**RE: National Construction Code (NCC) 2022 Volume One  
Amendment 2 Section J Part J4 Building Fabric Statement of  
Compliance**

**JOB NO.: 250138**

**SUBJECT PREMISE: Retail and Common Areas of 88 Waterloo Rd | 88 Waterloo Rd, Macquarie Park NSW 2113**

DOCUMENT No.: 250138  
 DOCUMENT TITLE: 88 Waterloo Rd - Building Fabric Requirement

1 DA2013 - LEVEL 5 1:200

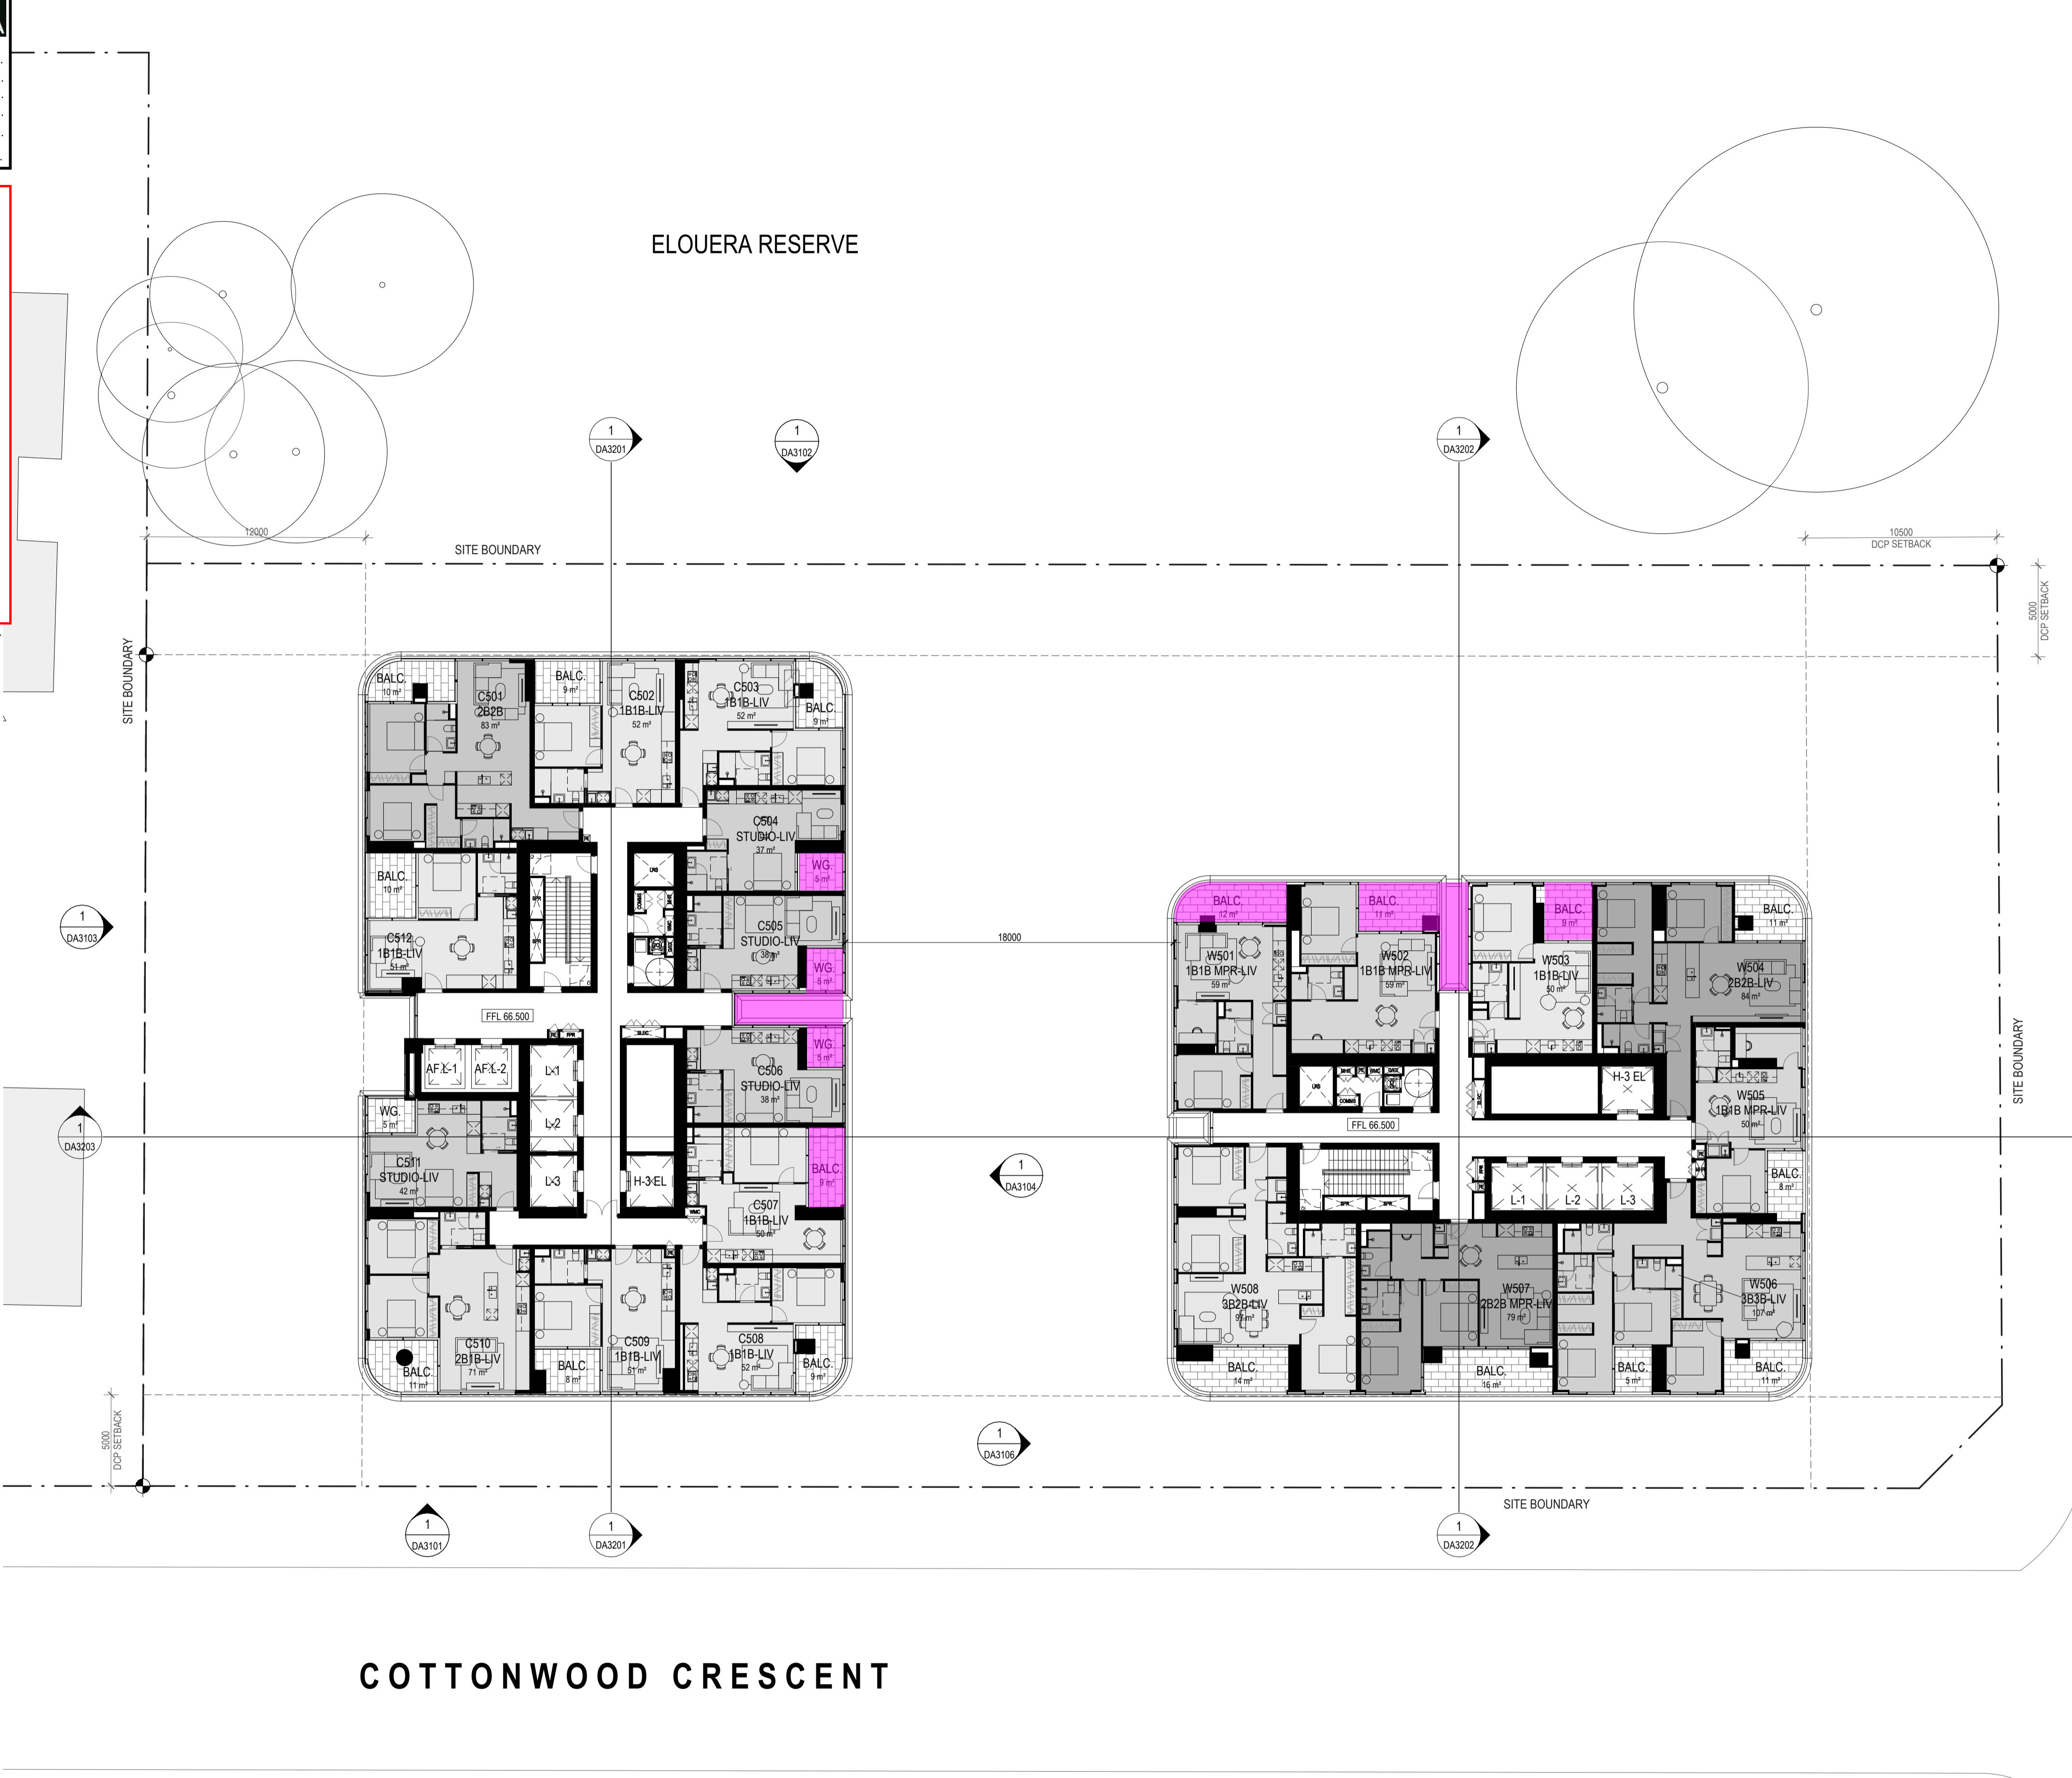
- ROOF/CEILING ENVELOPE: TOTAL R3.7 (DOWNWARD, SOLAR ABSORPTANCE NO MORE THAN 0.45)
- ENVELOPE FLOORS (SUSPENDED): TOTAL R2.0 (DOWNWARD)
- ENVELOPE FLOORS (SLAB-ON-GROUND): TOTAL R2.0 (DOWNWARD)\*
- ENVELOPE WALLS: TOTAL R1.4

Note: The above construction are only to be applied to the non-glazed portions of the envelope; glazing must be installed as per the architectural layouts with its thermal performances pursuant to the respective glazing specifications stated in the Section J report (Total Systems U-Value, and Total Systems SHGC value).
